Subject: Revised draft zoning amendments related to Housing Element (Item 7-B on 9-12-22 Planning Board agenda)

Subject: Revised draft zoning amendments related to Housing Element (Item 7-A on 9-26-22 Planning Board agenda)

Subject: Examples of Oakland and Berkeley projects incompatible with Alameda historic areas that could result from the Alameda Housing Element--Item 7-C on 11-3-22 Historical Advisory Board agenda

Attachment A: TOHW map

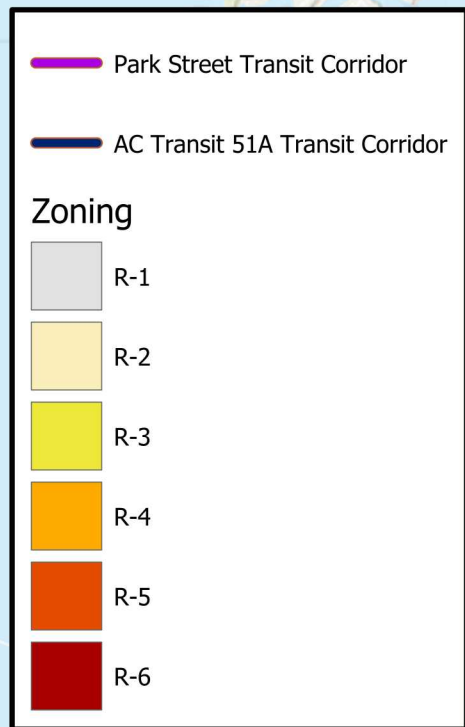
In addition, the TOHW mapping is based on the location of the "high frequency transit corridors", rather than an actual map or verbal description of the actual corridors (e.g. the 51A bus line) as they existed on the date of the zoning amendment adoption. **This is irresponsible and somewhat bizarre, since it appears to mean that the mapping of such corridors is under the control of AC Transit.** If AC Transit adds, deletes or changes a route, the half mile wide corridor would change accordingly with no action by the City of Alameda. To allow the City to retain control of the waiver mapping as well as make the provision more understandable to document users, **the waiver should be shown as a zoning map overlay**, such as shown on Attachment A, which was provided to the Historical Advisory Board at its June 2, 2022 meeting.
